1968 Convention on Road Signs and Signals: Section C, para 9 (c), (iv)

Sustainable Transport Division
Geneva, 29 August 2017

UNECE

MODELS OF ADDITIONAL PANELS
MODELES DE PANNEAUX ADDITIONNELS

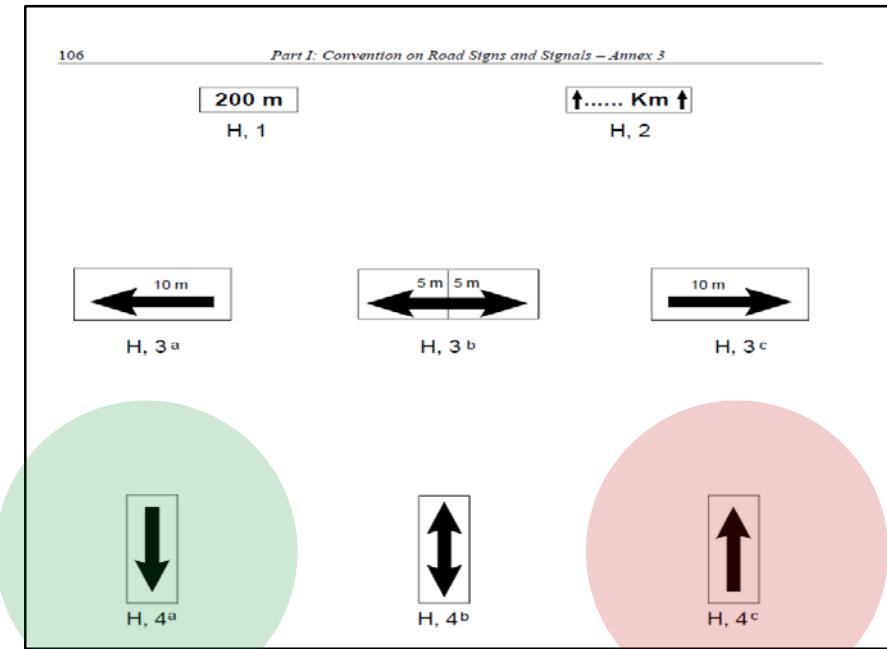
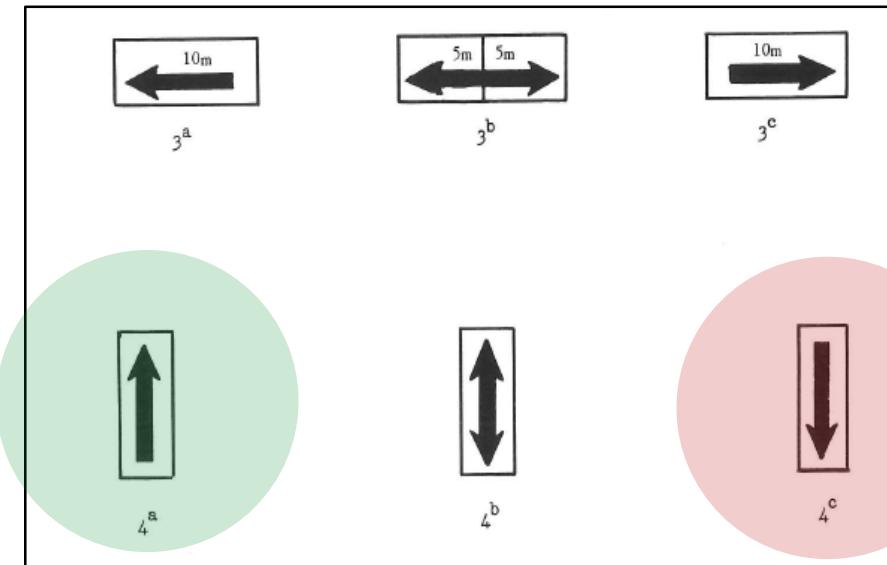
Printing error?

Error?

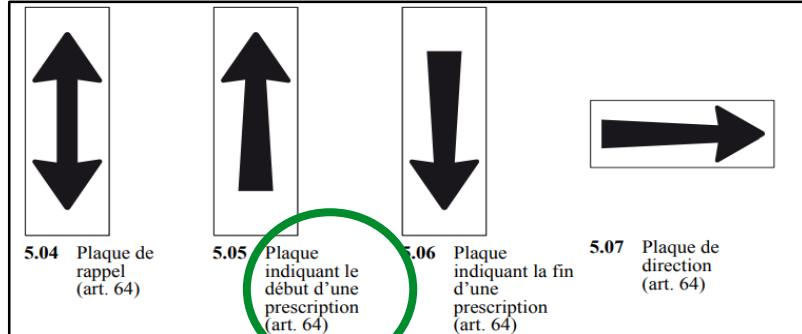
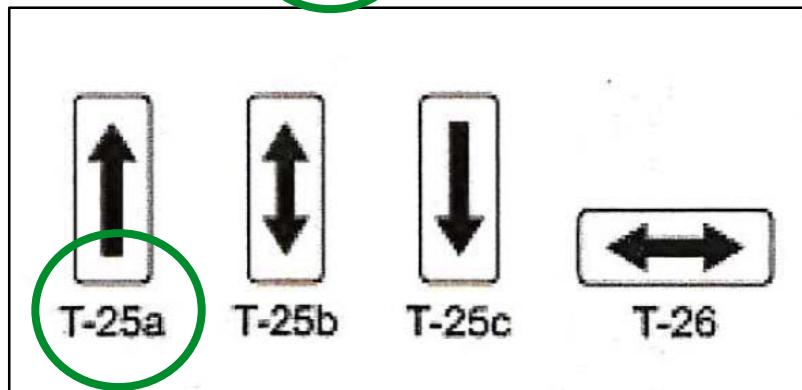
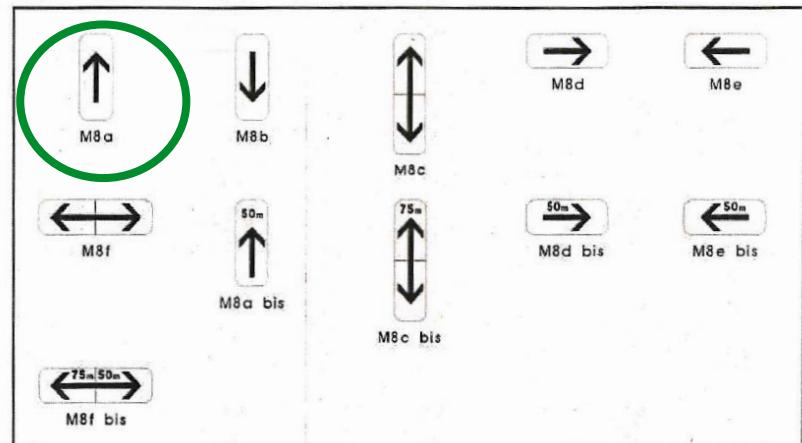
Begin Repeat End
